MEMORANDUM FOR: Docket File Nos. 40-8981; 40-8958

SUBJECT: SAFETY EVALUATION REPORT (SER) FOR URANERZ U.S.A., INC.,  
RUTH AND NORTH BUTTE PROJECTS

UNITED STATES NUCLEAR REGULATORY COMMISSION  
SAFETY EVALUATION REPORT  
PREPARED BY THE  
URANIUM RECOVERY FIELD OFFICE  
IN CONSIDERATION OF AN APPLICATION FOR TWO  
SOURCE MATERIAL LICENSE'S FOR  
URANERZ U.S.A., INC.  
RUTH AND NORTH BUTTE COMMERCIAL IN-SITU LEACH OPERATIONS  
LOCATED IN  
JOHNSON COUNTY AND CAMPBELL COUNTY, WYOMING  
DOCKET NO. 40-8958, SOURCE MATERIAL LICENSE SUA-1539  
DOCKET NO. 40-8981, SOURCE MATERIAL LICENSE SUA-1540

The Ruth Satellite Facility

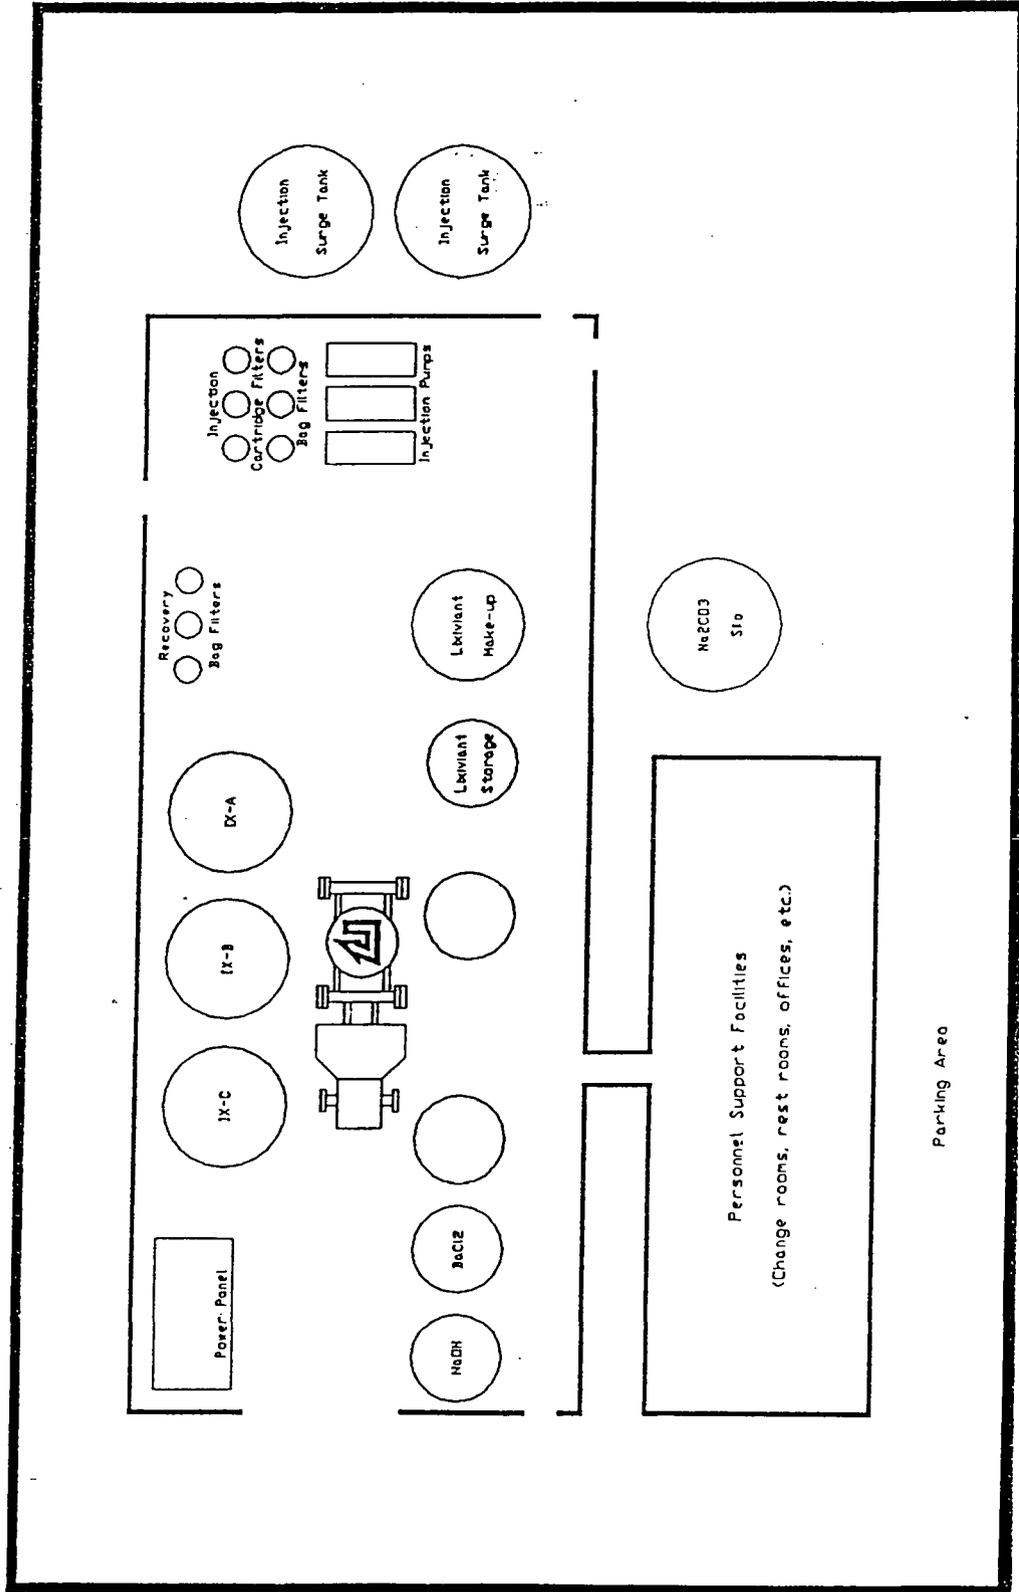
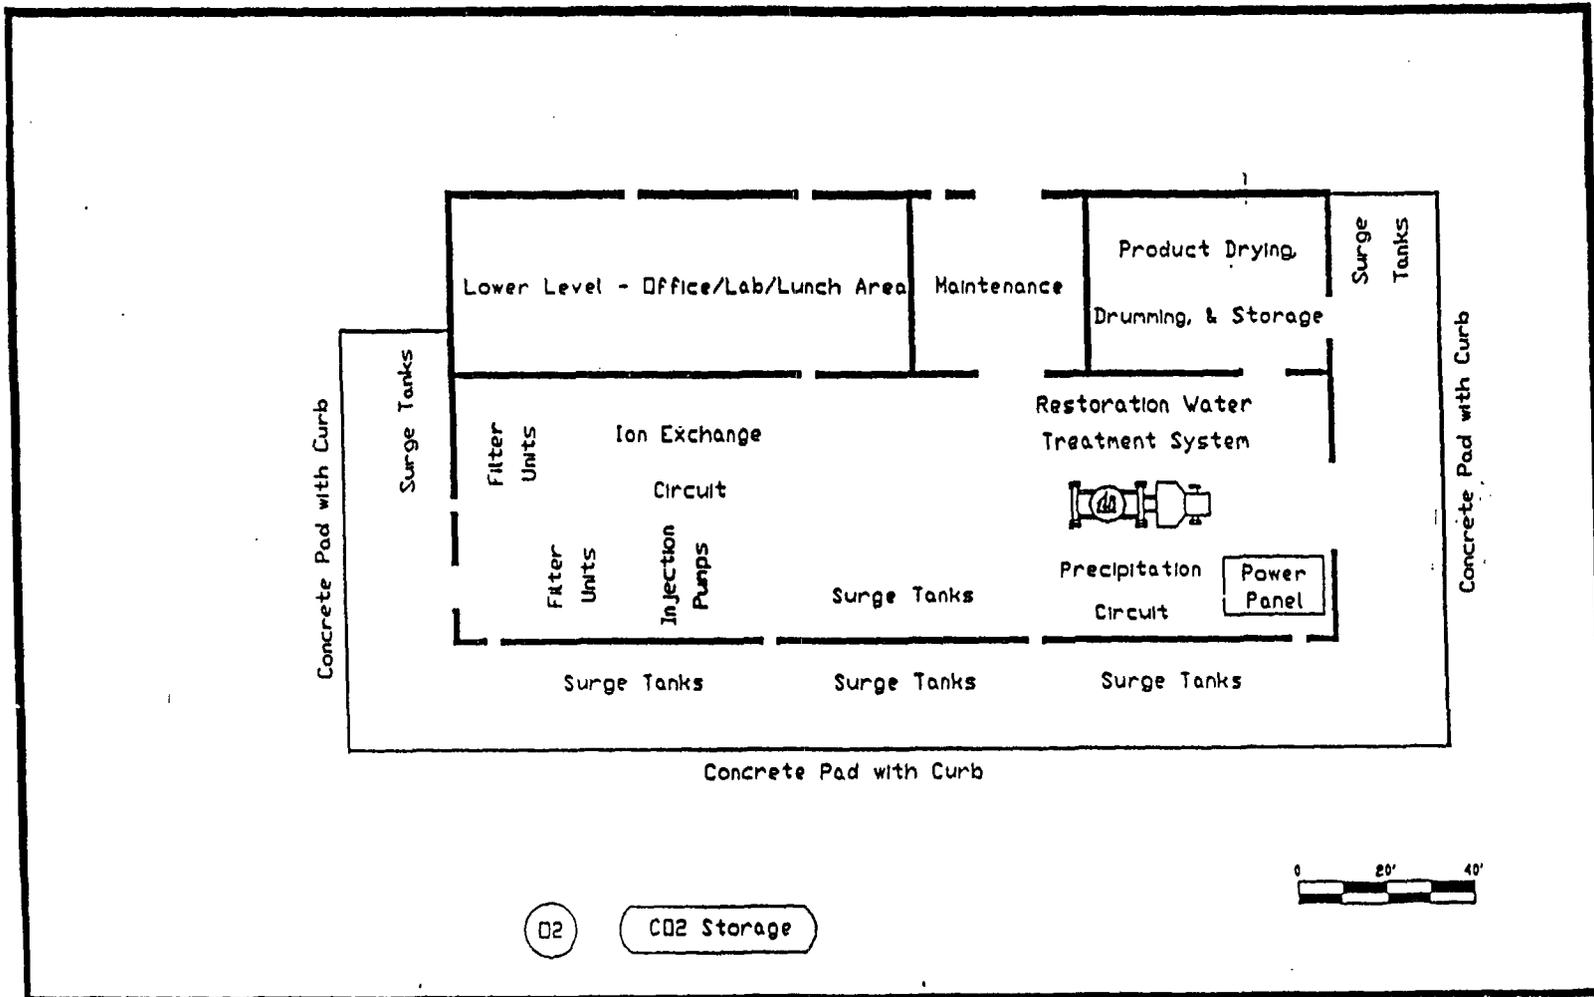
The Ruth site will be a 1000-gpm satellite facility that will rely on the North Butte main processing plant for yellowcake drying and packaging. Operations at the Ruth site will occupy the building that currently exists from the former Ruth R&D site. Similarly, the solar evaporation ponds that currently exist at the Ruth R&D site will be utilized for waste water disposal. Well field development will concentrate on the more heavily mineralized portions of the ore deposit. The plant configuration is shown in Figure 2.2.1.

The configuration of this process circuit is typical for this type of uranium recovery operation. To assure that the process circuit is not changed without adequate health and safety considerations, the licensee will be required by license condition to submit any proposed circuit change to the configurations shown in Figures 2.2.1 and 2.2.2, to the NRC for review and approval.

- Any significant changes in the process circuit as show in Figure 15.19 of the application, dated October 3, 1988, shall require approval by the NRC, Uranium Recovery Field Office, in the form of a license amendment.

Ruth Radiological  
Sampling Stations

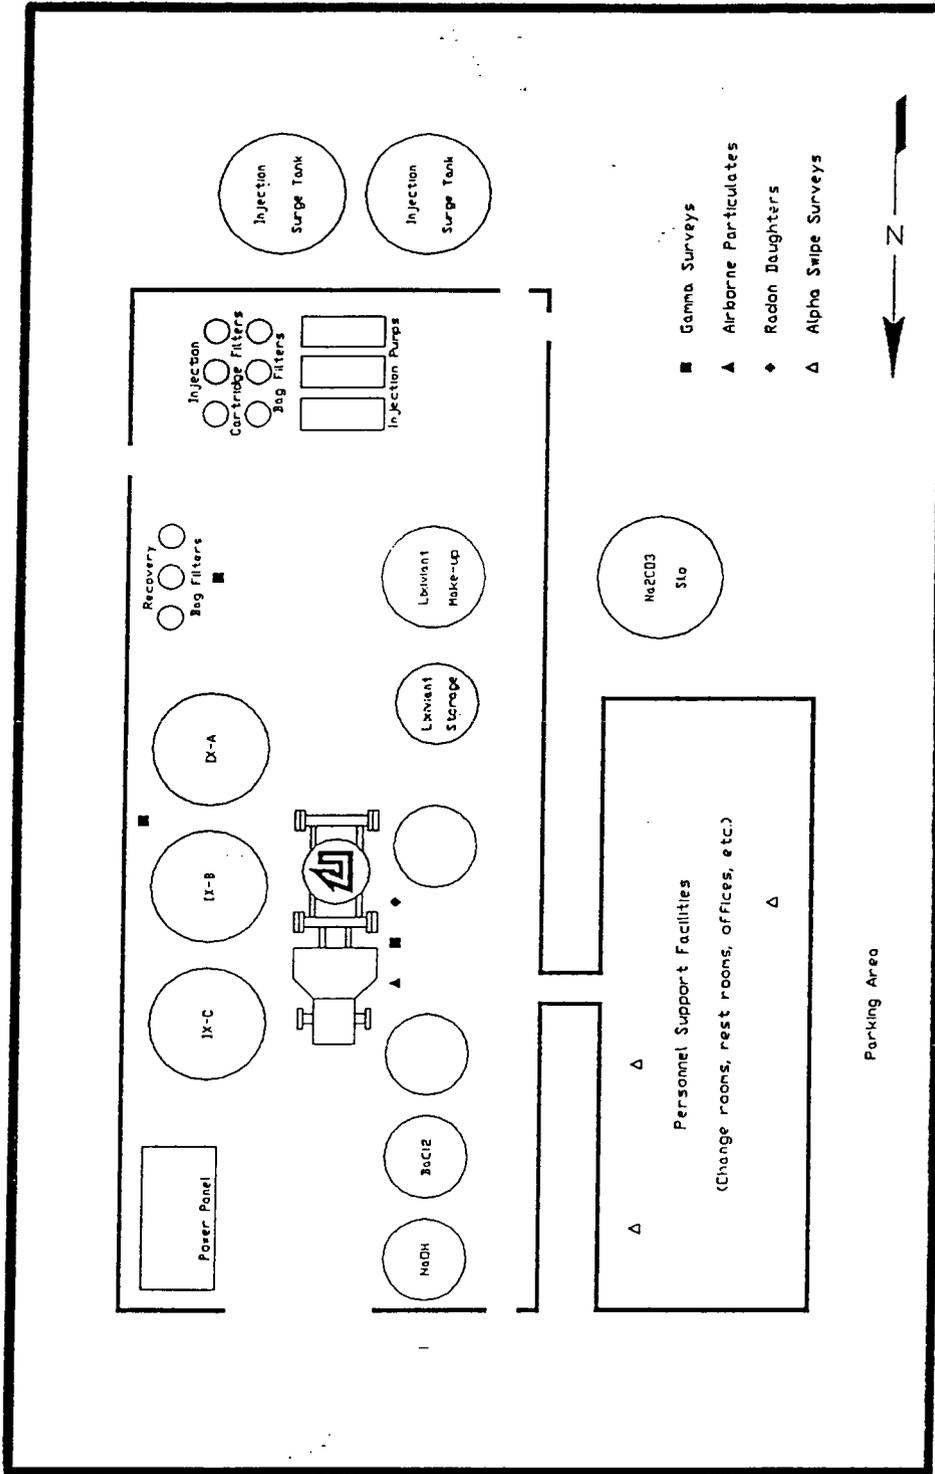
The various monitoring locations at the Ruth and North Butte facilities are shown on Figures 4.2.1 and 4.2.2 respectively. These monitoring locations with the frequencies specified above will be required by license condition.

Uranerz has proposed to conduct gamma exposure rate surveys at the Ruth site on a semiannual frequency and at the North Butte facility on a quarterly frequency. The surveys will be performed at the locations shown in Figure 4.2.1 and 4.2.2. Because these are new facilities and there is an unknown potential for gamma exposures, due to solutions high in radium, the frequencies proposed by Uranerz are not adequate. Uranerz will, therefore, be required by license condition to perform gamma surveys on a monthly frequency for both the Ruth and North Butte sites. After the sites have been characterized and if the data supports it, a reduction in monitoring frequency may be appropriate after review and approval by NRC.

- The licensee shall implement the radiological surveys specified in Sections 19.1.7.2, 19.1.7.5, 19.1.7.6, and 19.1.7.8 at the locations specified in Figure 19.2 of the application dated, October 3, 1988. Additionally, alpha surveys, at the designated locations shall be conducted weekly and gamma surveys shall be performed monthly.

North Butte Radiological  
Sampling Stations

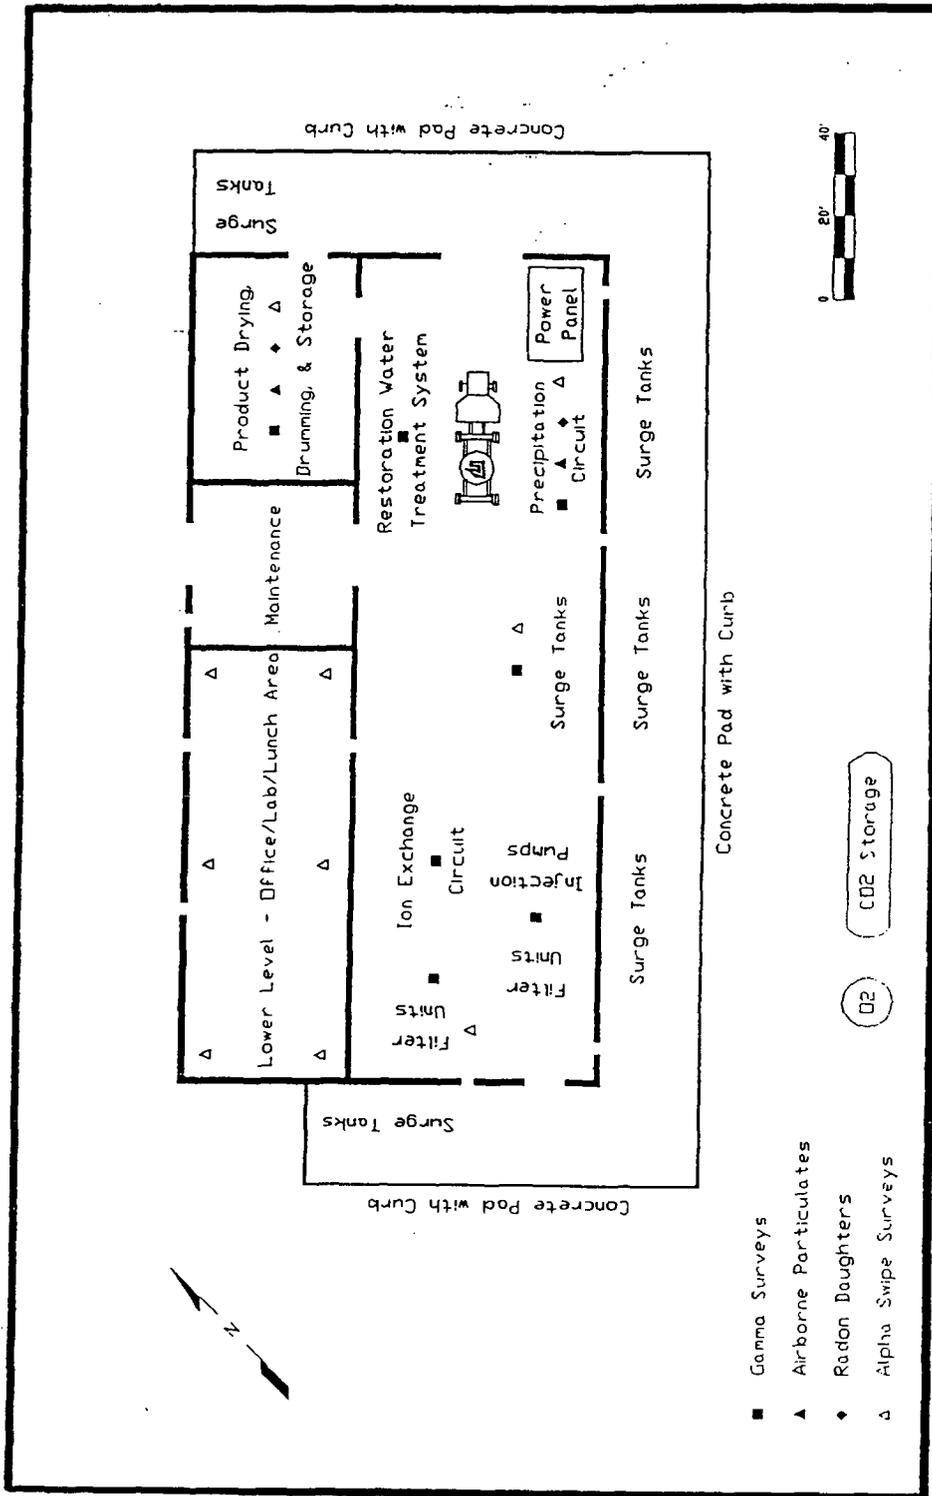
The proposed alpha survey locations at the North Butte site include the office, change rooms, and lunch areas as well as several locations within the process building. These locations appear to be appropriate.

- The licensee shall implement the radiological surveys described in Sections 19.1.7.2, 19.1.7.5, 19.1.7.6, and 19.1.7.8 at the locations specified in Figure 19.2 of the application dated, March 7, 1989.

Additionally, alpha surveys, at the designated locations shall be conducted weekly and air particulate monitoring shall be performed every time the dryer is utilized. When the dryer is not being used particulate monitoring shall be administered on a weekly frequency. Gamma surveys shall be performed monthly.
